Access Compliance Report

Public Rights-of-Way

Intersection ID: 28651	Main Street: MARVIN_RD	Cross Street: PRINCETON_COMMONS_DR	Location: NE
ADA ID: 7D5E4C690800	Ramp Type: Perp	Initial Pass/Fail: Fail	Overall Compliance: No
Severity Score: 42.5			
Codes/Mitigation Info/Possible Solution		Field Measurements/Component Compliance

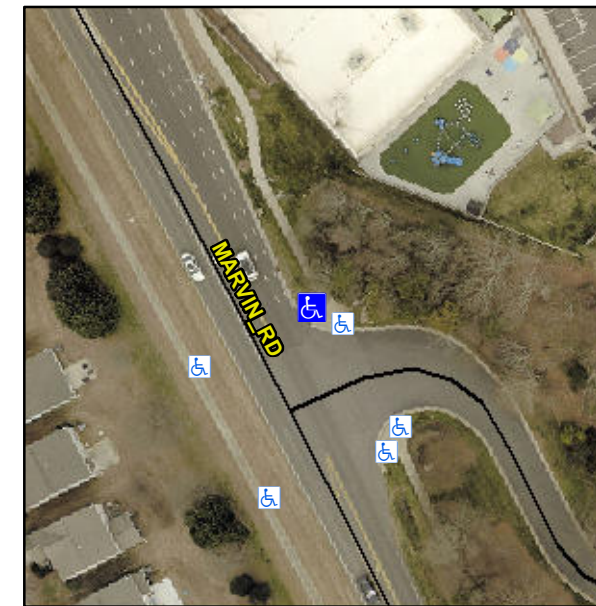
Remove & Replace Entire Ramp.

R304.5.1, R304.5.3

Compliance	Description	Data	Compliance	Description	Data
N/A	Ramp Length (in)	137.0	Yes	Ramp Slope (%)	7.7
No	Ramp Width (in)	33.0	No	Ramp XSlope (%)	9.6
N/A	Flare Type LT	N/A	N/A	Flare Type RT	N/A
N/A	Flare Slope LT (%)	N/A	N/A	Flare Slope RT (%)	N/A
N/A	Flare Traversable LT?	N/A	N/A	Flare Traversable RT?	N/A
N/A	Landing Length (in)	N/A	N/A	DWS Provided?	N/A
N/A	Landing Width (in)	N/A	N/A	DWS Contrast?	N/A
N/A	Landing Slope (%)	N/A	N/A	DWS Length (in)	N/A
N/A	Landing X Slope (%)	N/A	N/A	DWS Full Width?	N/A
N/A	Landing Curb? (Y/N)	N/A	N/A	DWS Offset (in)	N/A
N/A	Shared Landing?	N/A			
N/A	Gutter Ponding?	N/A	N/A	Gutter Slope (%)	N/A
N/A	Gutter Lip Ht (in)	N/A	N/A	Gutter X Slope (%)	N/A
N/A	Painted X Walk1?	No	N/A	Painted X Walk2?	N/A
	X Walk 1 Direction	To SW		X Walk 2 Direction	N/A
N/A	X Walk 1 Width (in)	N/A	N/A	X Walk 2 Width (in)	N/A
	X Walk 1 Slope (%)	5.8		X Walk 2 Slope (%)	N/A
	X Walk 1 X Slope (%)	4.8		X Walk 2 X Slope (%)	N/A
